Office Action Summary

10/016,132

DETAILED ACTION

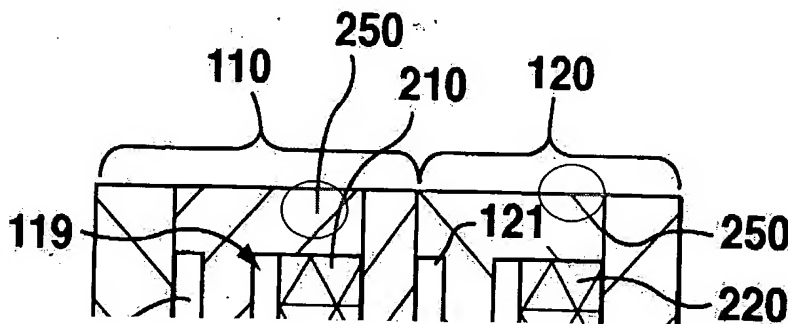
3. The Replacement Figures 6 and 8 were received on 13 August 2004. These drawings are acceptable.
4. The drawings filed on 11 March 2002 are objected to as failing to comply with 37 CFR 1.84(p)(4) because reference character "250" in Fig. 1a has been used to designate, both, a rim and an external wall of reactor stack. See below reproduced cutout of Fig. 1a with added markings to clarify the objection:

Corrected drawing sheets in compliance with 37 CFR 1.121(d) are required in reply to the
